From: Davies, Liam (Highways)
Sent: 06 January 2025 14:23
To: Glover, Kate
Subject: 24/0272

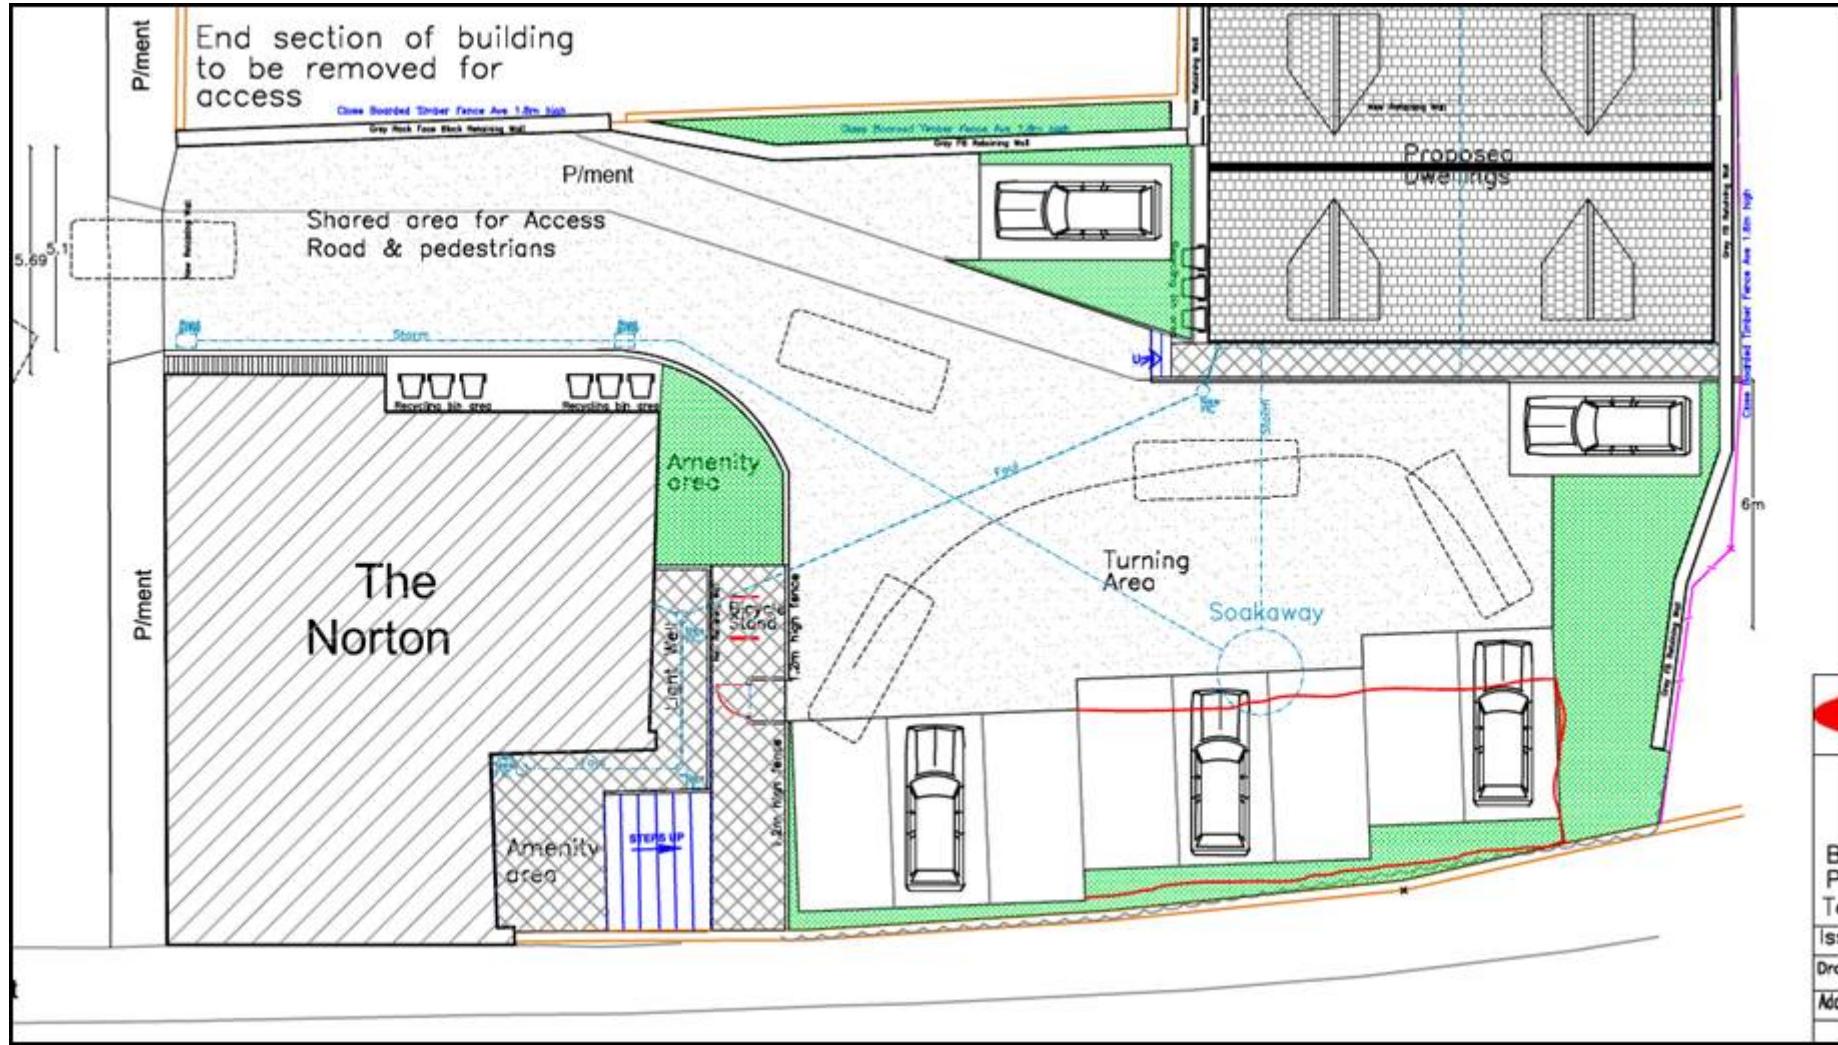
- 1) Can the footway shown within the north of the site be removed (I've shown the extent marked in red below). This is a shared use area therefore no footway is needed and the steps are not DDA compliant.. Due to the narrowness of the footway along the property frontage it is not practical and it would be better if the footway was removed. If the applicant wants a safety feature I would suggest placing bollards at the frontage however this is not really necessary due to low traffic and low speeds

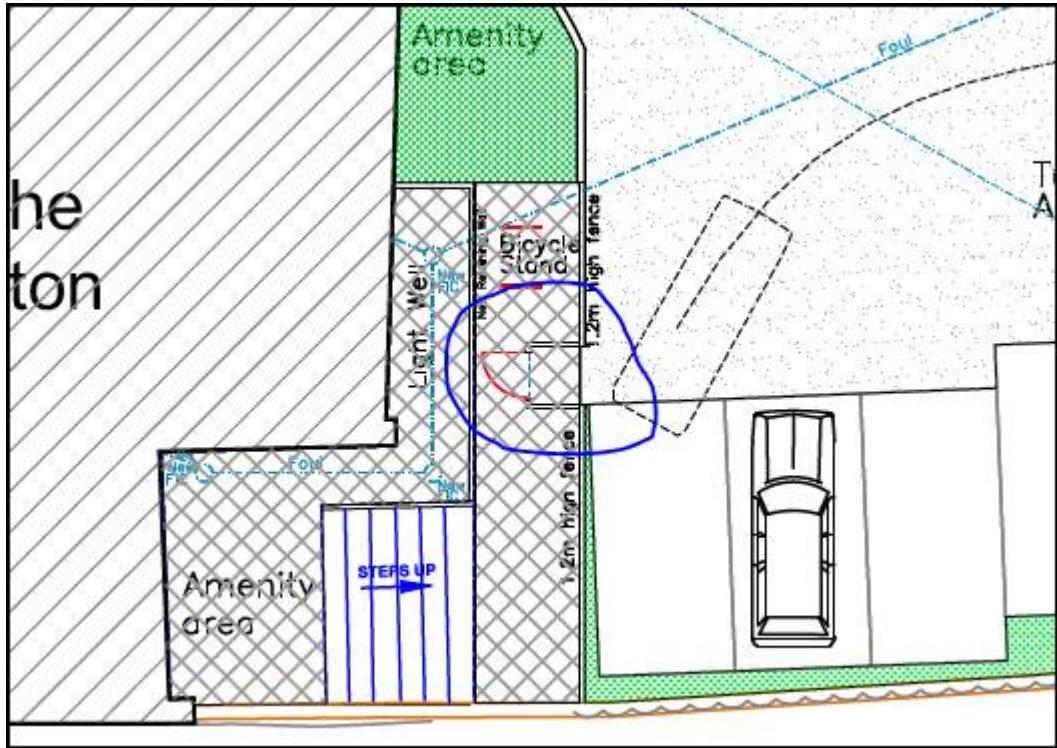
2) Can the spaces to the south of the site be made flush with one another (shown in red)? I can't see any reason as to why they need to be stepped the way they are. The applicant will still need to maintain the 4.8m length for each bay. See below:
